GW - 28

**GENERAL
CORRESPONDENCE**

A meeting to discuss the Navajo Refining Company Discharge Plan was held at 9 o'clock a.m. on February 11, 1988, in the Oil Conservation Division Conference Room, State Land Office Building, Santa Fe, New Mexico. The following people attended the meeting:

RE: Discharge Plan for Navajo Refinery, DP-28

LOCATIONS OF WELL POINTS

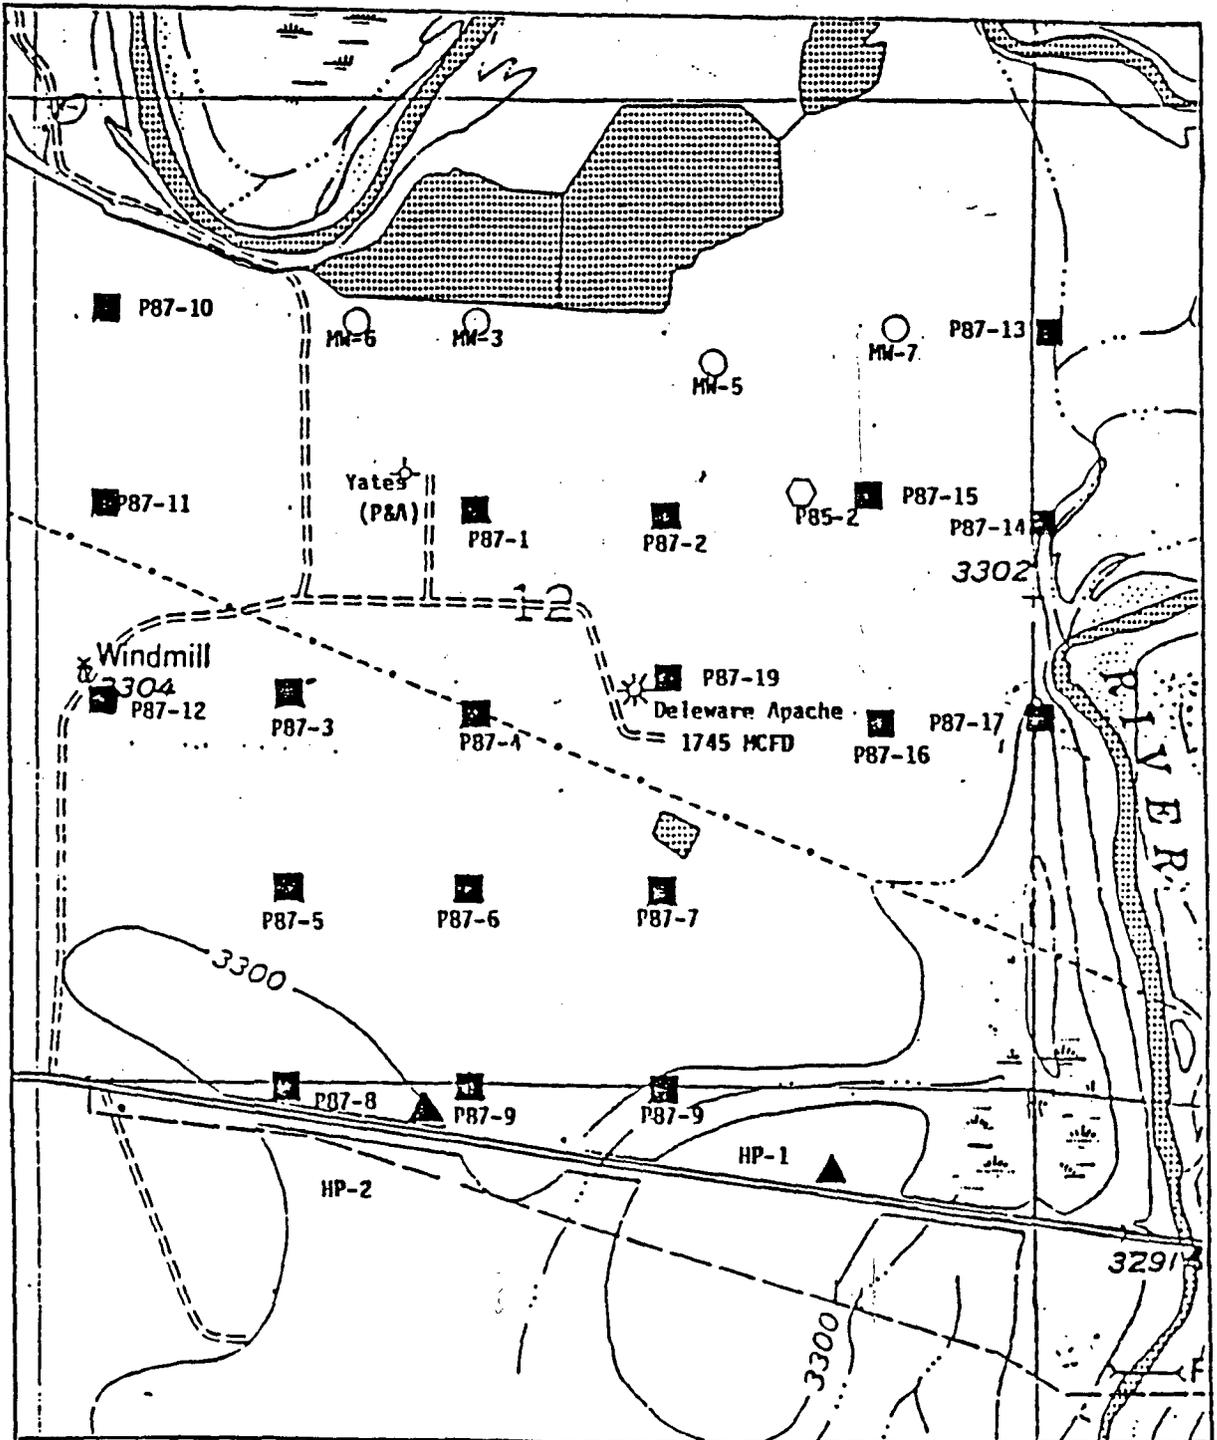
1. A well is being required by OCD to be located at the southern boundary of the proposed 80-acres to be acquired by Navajo. The east-west location is to be determined after submittal of water levels in several of the well points installed by Navajo in the spring of 1987. These points are not useful for water quality monitoring but are excellent for use as piezometers to determine flow direction from the ponds. If they can be located, stabilized and surveyed they can provide much meaningful data with little additional expense. The points necessary to establish water levels for a location for a new monitor well are:

P 87-1	P 87-14
P 87-2	P 87-15
P 87-3	P 87-16
P 87-4	P 87-17
P 87-13	p 87-19

Provide elevation and water levels for these points. In addition please provide water levels (and elevation and location data if not previously

supplied and/or verified) for MW-3, 4, 5, 6, and 7. All water levels for well points and monitoring wells should be taken the same day if possible.

Figure 6-1
TYPICAL MONITOR WELL DESIGN

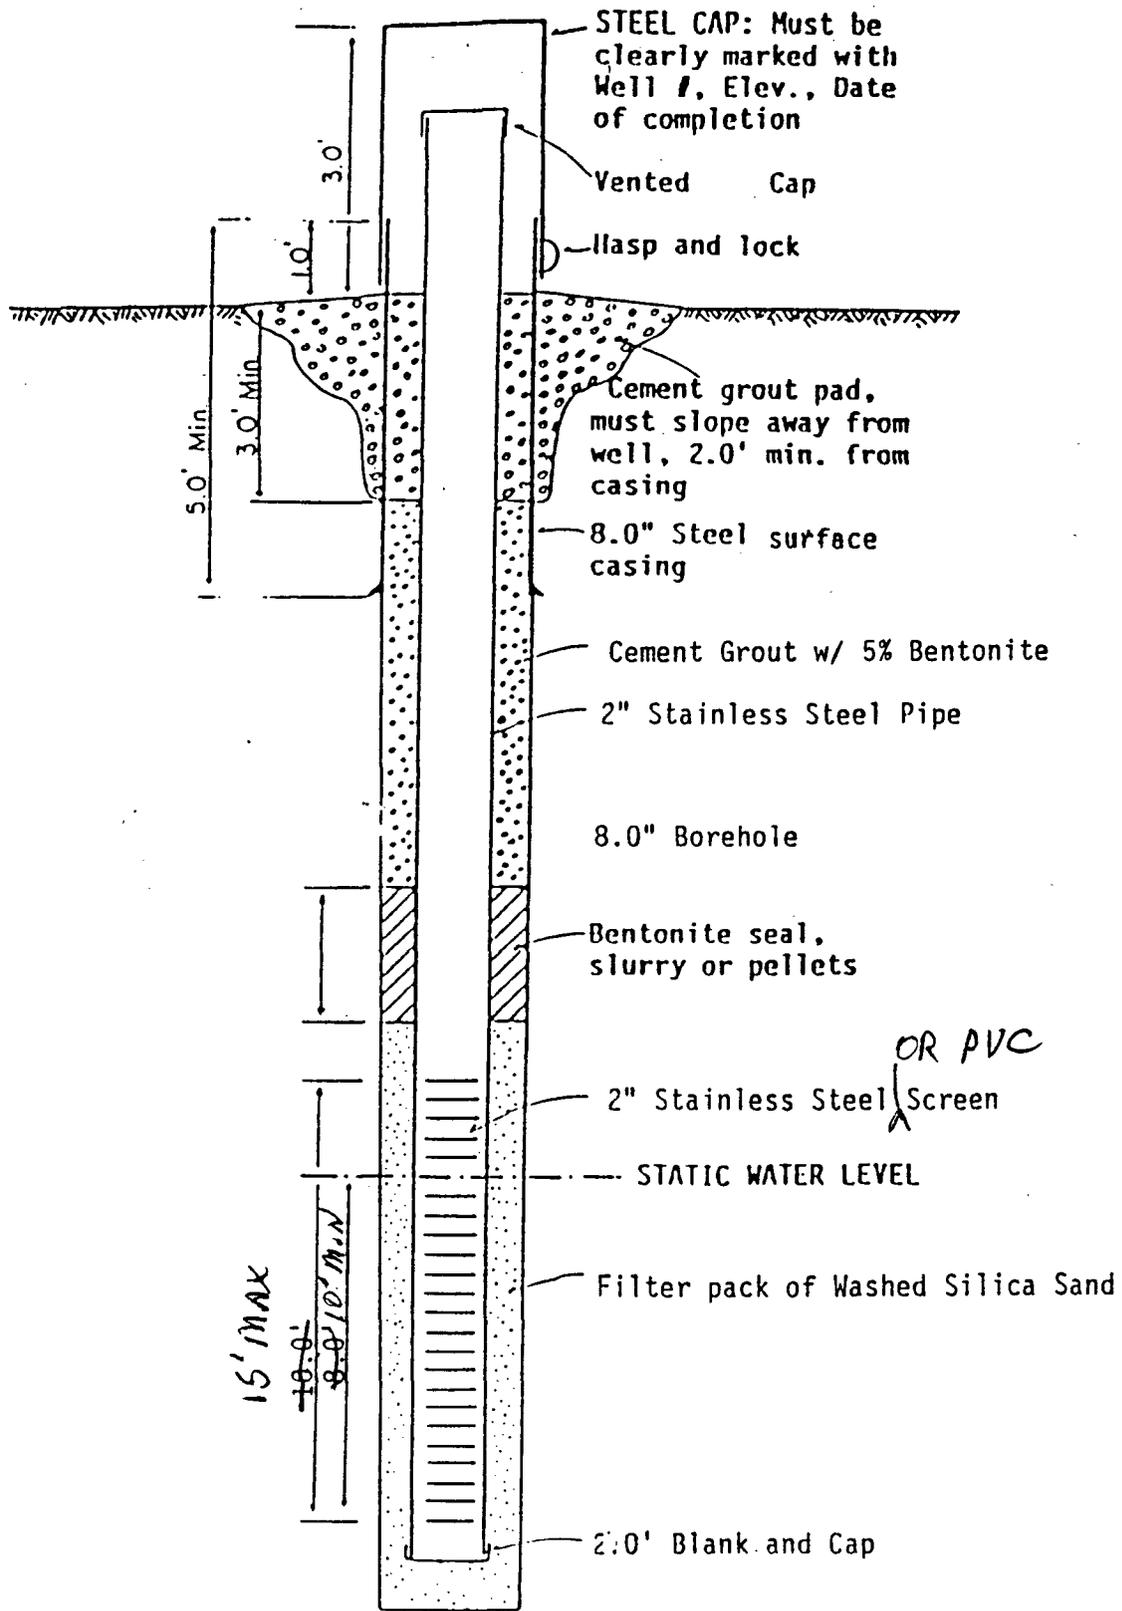
3. Attached is a typical monitor well of the design used in the earlier RCRA wells that you can use as a guide. Our only requirements are that you have a minimum of ten (10) feet of saturated thickness but that the maximum saturation does not exceed fifteen (15) feet, that the top of the screen not be submerged, that the filter pack top be placed about 12 inches above the top of the screens (to prevent bentonite migration) and that adequate surface casing and cement be placed to stabilize and seal the well. PVC may be used instead of stainless steel for the well itself.
